TO: Mercedes-Benz Dealer Principals, General Managers, Sales Managers, Service Managers, Parts Managers	FROM: Thomas Brunner, Department Manager, Vehicle Compliance and Analysis, Engineering Services
RE: Recall Campaign Launch 2017020018 - MY 2017 213 (E-Class) Replace Steering Column Module	DATE: March 24, 2017

Campaign No. 2017020018, March 2017

SUBJECT: **Models 213, Model Years 2017 Replace
Steering Column Control Module**

Figure 1

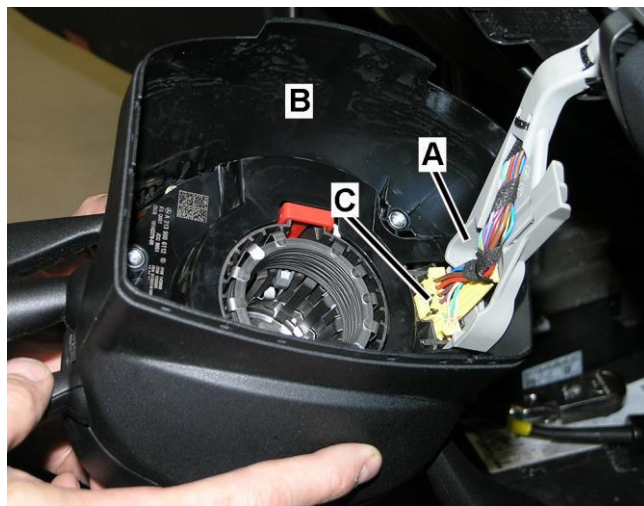
- Make sure that the wheels or the steering are/is in straight-ahead position.
- To remove cable duct (A, Figure 1) from steering column control module housing (B): Disconnect harness connector (C) from connector socket then unclip cable duct (A, Figure 2) from inside of steering column control module housing (B) and remove.
